m/023/007

March 6, 2001

RE: North Lily Mining Company - Post Closure Fluid Management System (PCFMS) Plan:
Final Design Modifications

ATTACHMENT 1
Topographic and Facility Location Map

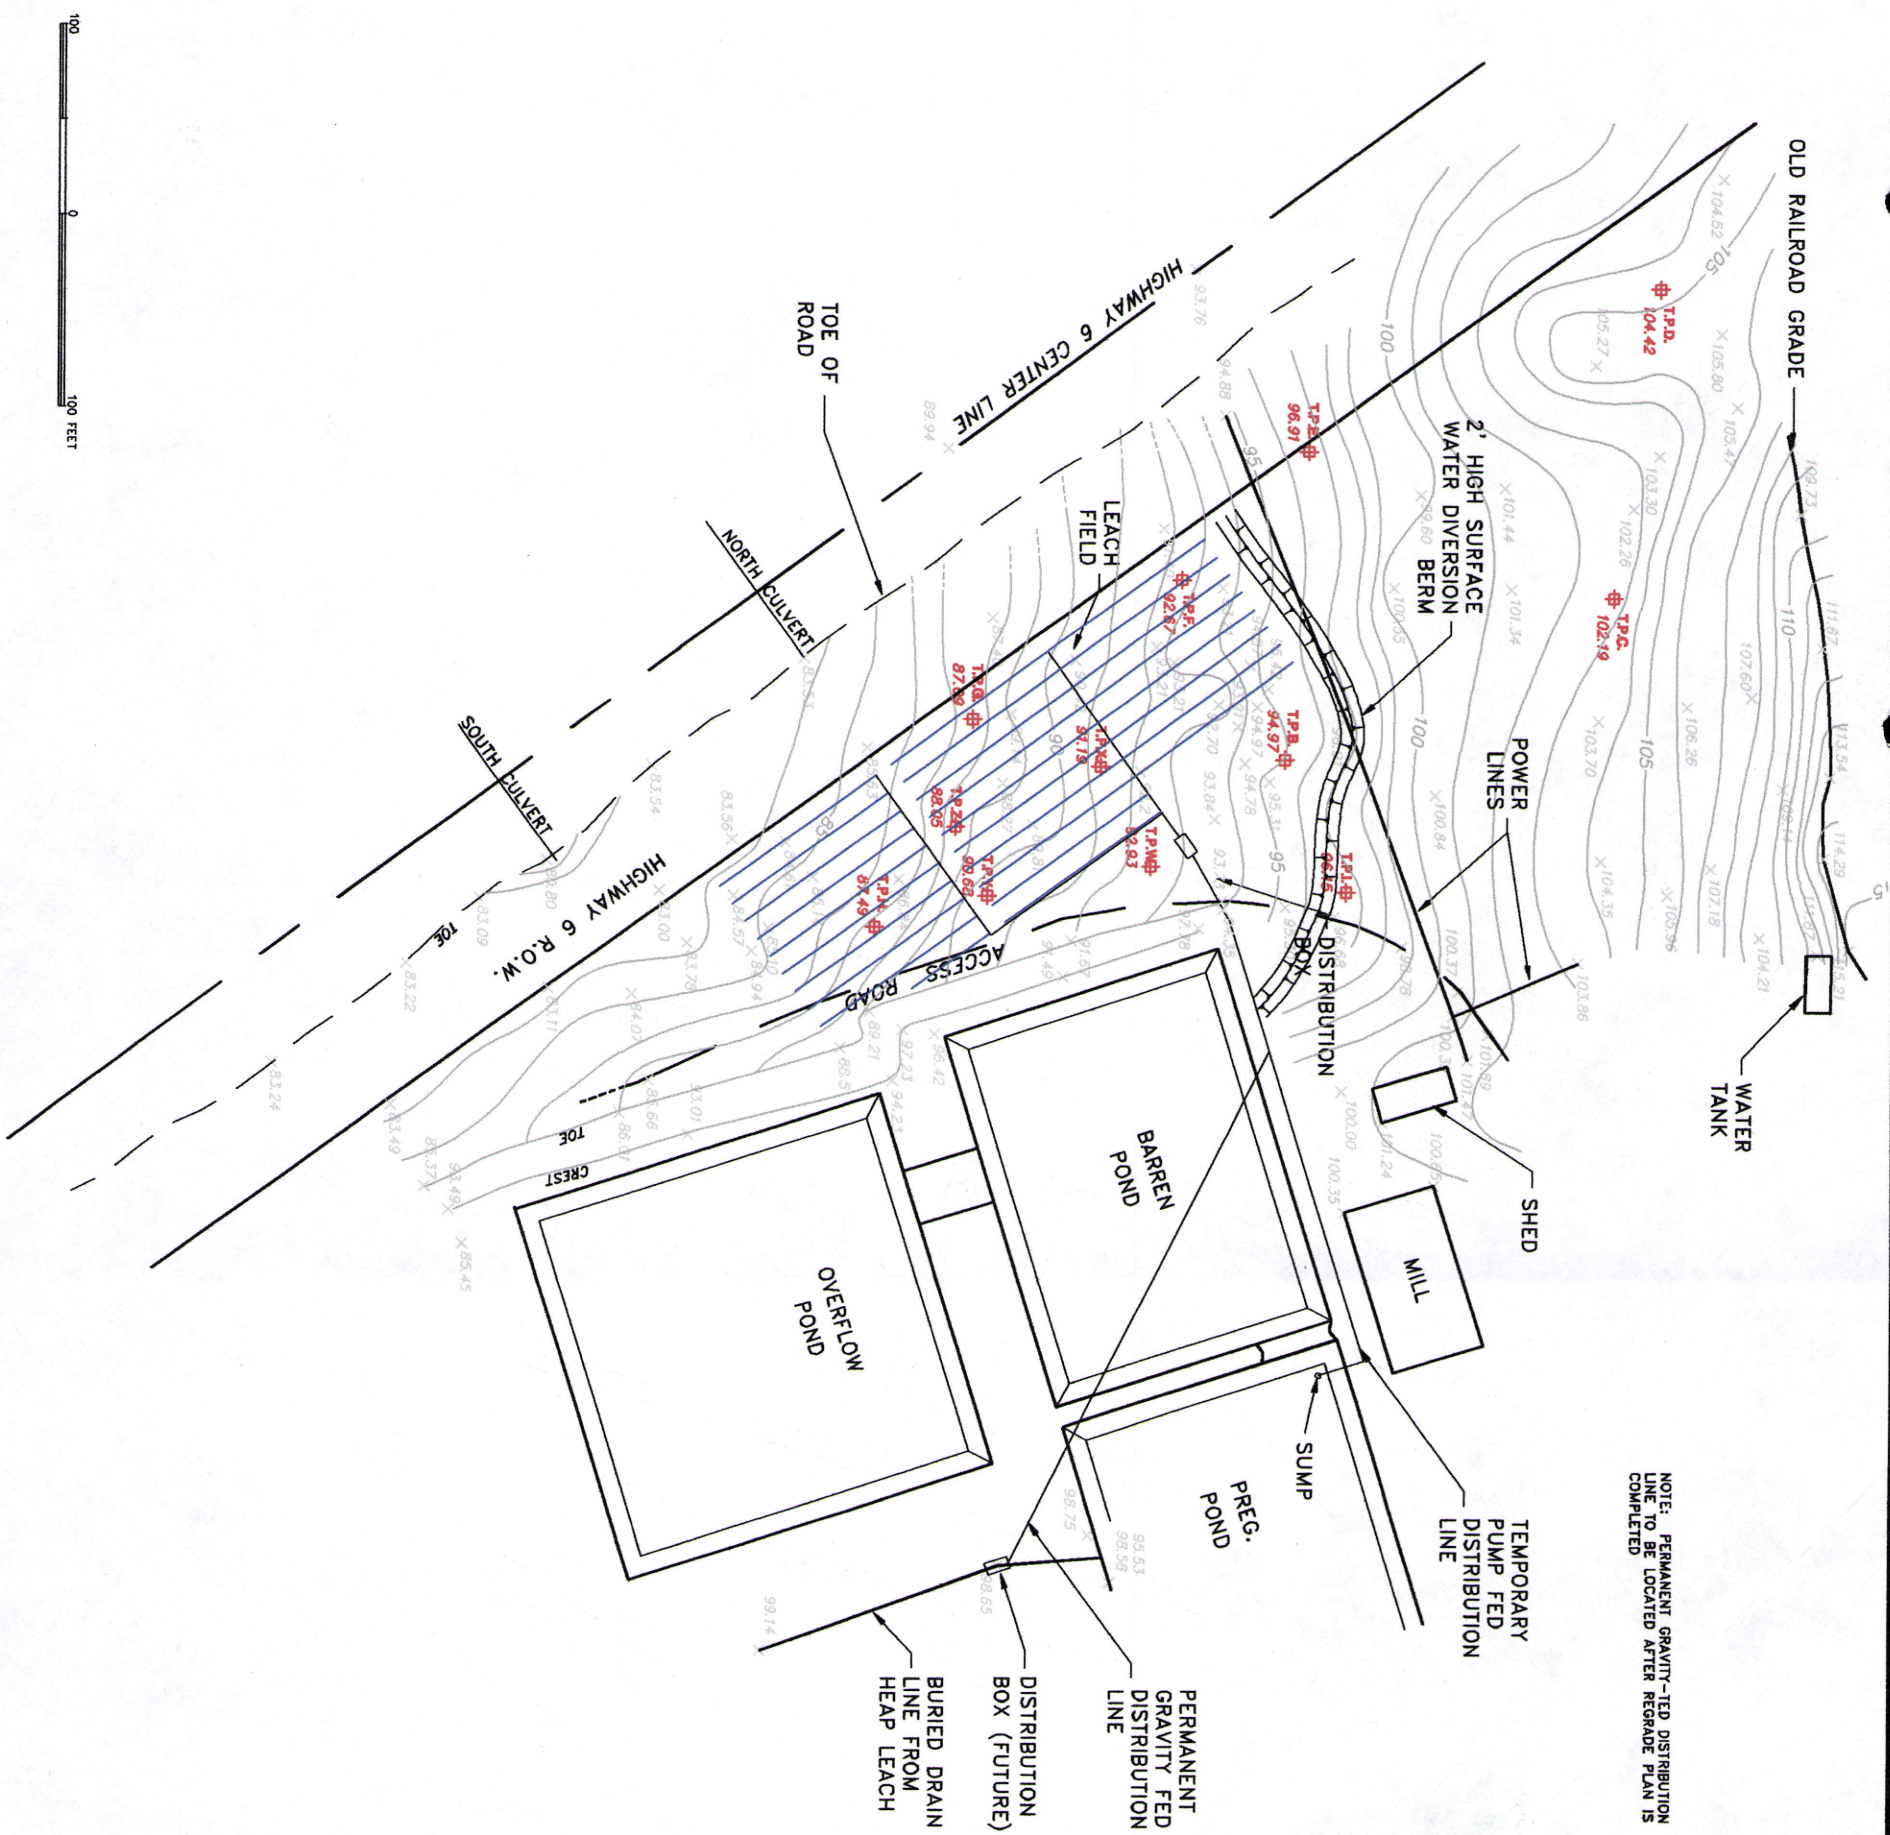
Four additional percolation tests have been completed in the area of the revised leachfield location. The location of these tests, designated W, X, Y, and Z, are shown on the revised topographic and facility location map, Attachment 1. The results of these tests are shown in the table provided in Attachment 2 entitled, North Lily Percolation Test Information.

The layout shown on Attachment 1 has this capacity and can be constructed on a single level.

3. Refer to the attached map to find the location of the two equalizing basins (distribution boxes).
4. The proposed location of the gravity drain line is also shown on Attachment 1.

5. The topographic map (Attachment 1) has been expanded to show the toe and crest of the barren and overflow pond berms as well as the adjacent topography. As this map shows, no impact to the pond berms would occur due to leachfield construction. Note that the proposed gravity drain line from the pad margin distribution box to the leachfield distribution box is shown to cross a corner of the barren pond. This location was selected to prevent the need for right angle bends in the pipeline; however, to locate the pipeline in this location, use of the barren pond for site debris disposal (including the entire pond PVC liner) would be confined to the western half or two-thirds of the pond and earthen fill would be placed in the eastern portion of the pond to enable burial of the pipe. If the debris volume is such that this will not be possible, the proposed final pipeline location would be modified and submitted to DWQ for approval.

6. The location of the sump pump in the pregnant pond is also shown on Attachment 1. The initial pump-supplied temporary line is located adjacent to the north and west sides of the barren pond, as shown on the map. Two attached sketches (Attachment 3), Sketch 1 and Sketch 2, show Typical Trench Layout and Lateral Connection and Typical Lateral Trench Cross-section, respectively.
